**Planning Application YR-2021/916 - 25-27 Songbird Avenue Chirnside Park – Planning Report – Planning Report**

<b>Site Address</b>	25 and 27 Songbird Avenue Chirnside Park
<b>Application No.</b>	YR-2021/916
<b>Proposal</b>	Use and Development of a Childcare Centre
<b>Existing Use</b>	Single Dwelling on both lots
<b>Applicant</b>	U. Bhatia
<b>Zone</b>	Neighbourhood Residential Zone Schedule 1 - NRZ1
<b>Overlays</b>	Significant Landscape Overlay Schedule 23 – SLO23 <ul style="list-style-type: none"><li>• Clause 32.09-2 - Use of the Land for as a Childcare Centre.</li><li>• Clause 32.09-9 - A permit is required pursuant to construct a building or construct or carry out works for a use in Section 2</li></ul>
<b>Permit trigger/s</b>	
<b>Submissions</b>	Thirty-two (32) objections and one (1) in support
<b>Encumbrances on Title (Covenants/Section 173 Agreements)</b>	No
<b>Reason for Council Decision</b>	More than 10 Objections
<b>Ward</b>	Chirnside

**Figure 5 -Tree Designations from Future Tree Health Arboricultural Impact Assessment**

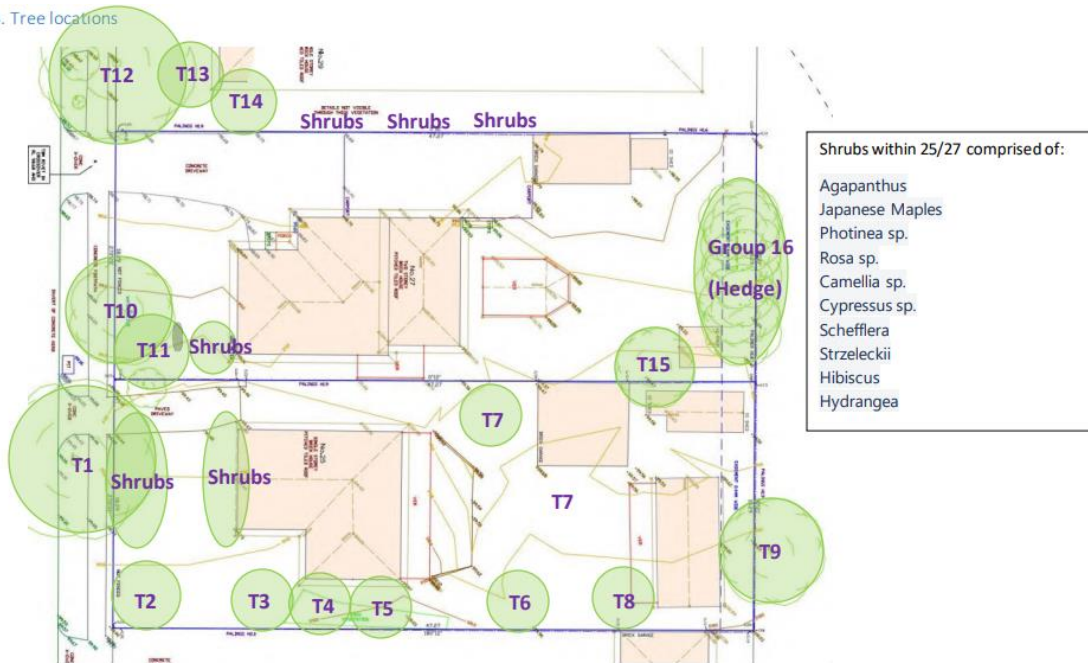
The Arborist assessment has been reviewed and accepted by Council’s arborist, who has no objection to the proposal provided standard tree protection measures to protect retained and adjoining vegetation is adhered to.
